DOCUMENT 00 90 00
ADDENDUM

ADDENDUM NO. [1] **Date: January 30, 2020**

RE: **WITC – RICE LAKE CAMPUS**
PARKING AND SIGNAGE
1900 COLLEGE DRIVE
RICE LAKE, WI
HSR PROJECT NO. 19023-3

10
C7

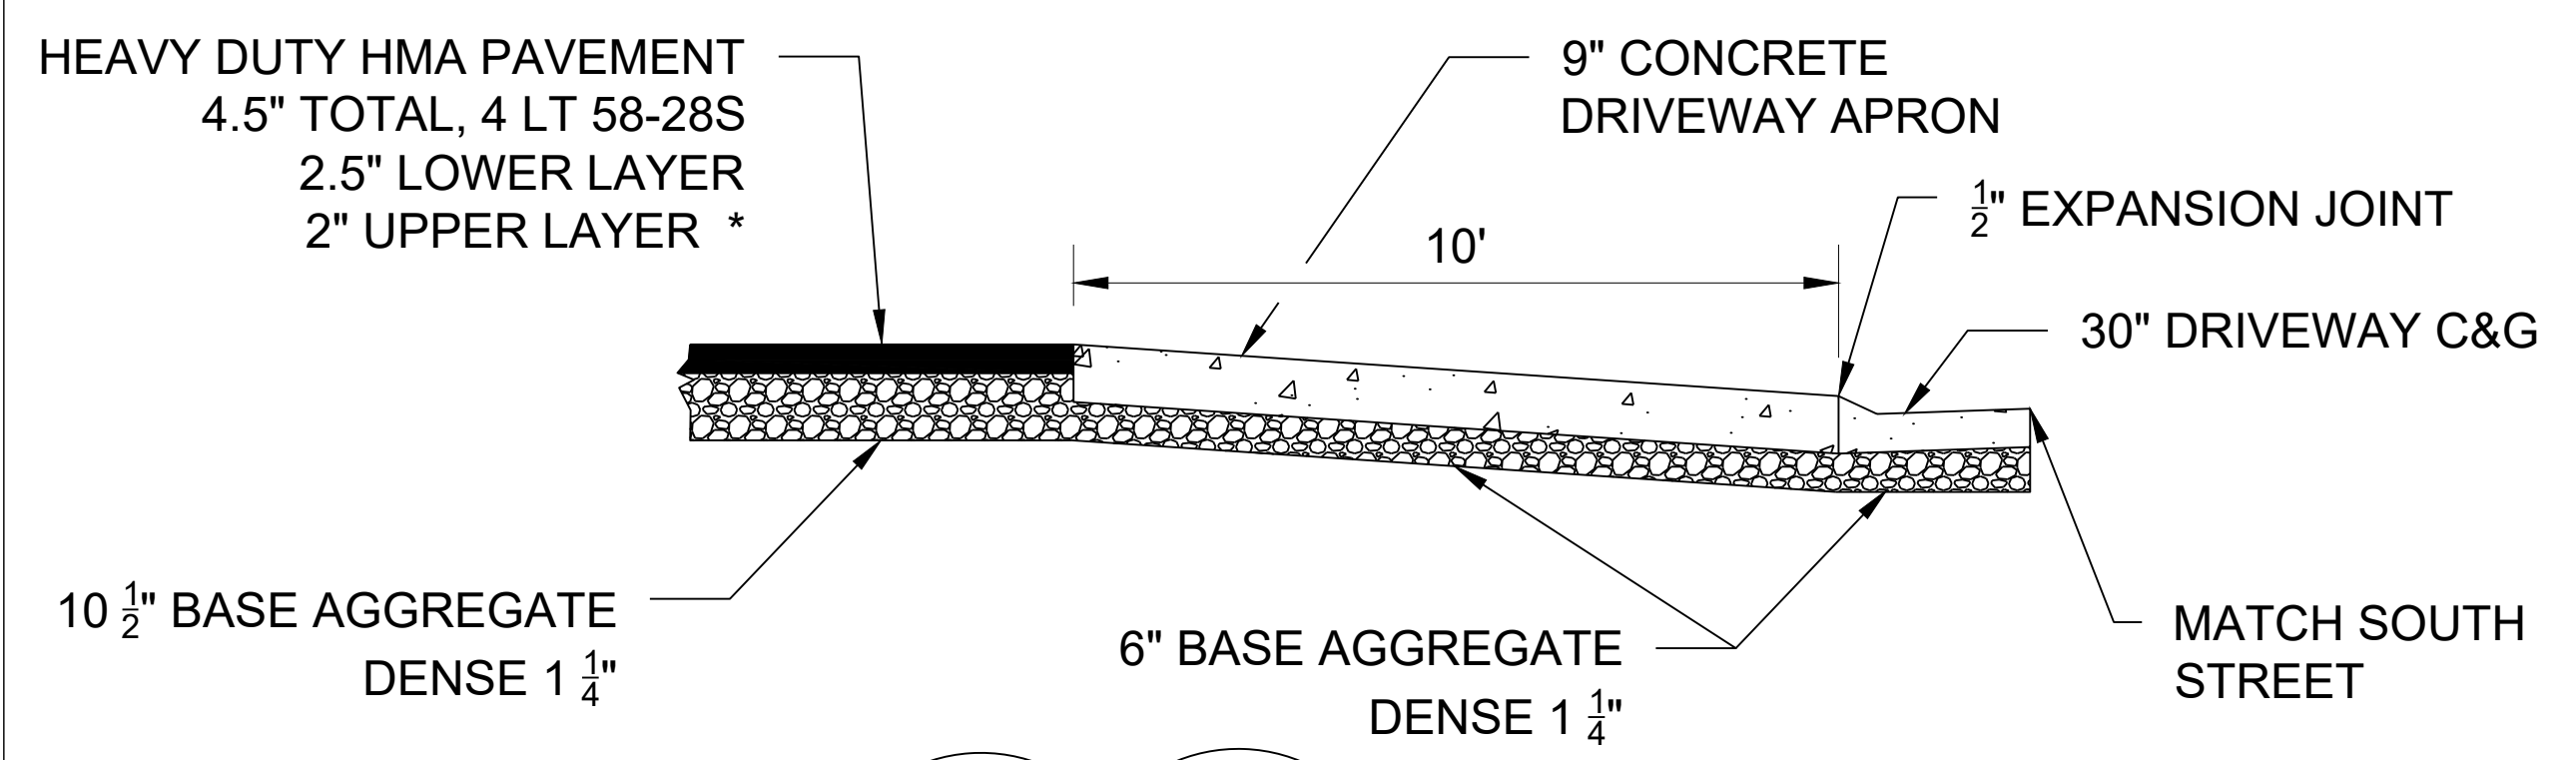
12. C7 DETAILS 24 x 36 attached hereto
 - a. Revisions clouded on Drawing.
13. C9 DETAILS 24 x 36 attached hereto
 - a. Revisions clouded on Drawing.

** FROM PAST PROJECT RECORDS
* THE AIR VOIDS REGRESSION PER WISDOT WILL NOT APPLY TO ASPHALT PAVEMENT

* THE AIR VOIDS REGRESSION PER WISDOT WILL NOT APPLY TO ASPHALT PAVEMENT
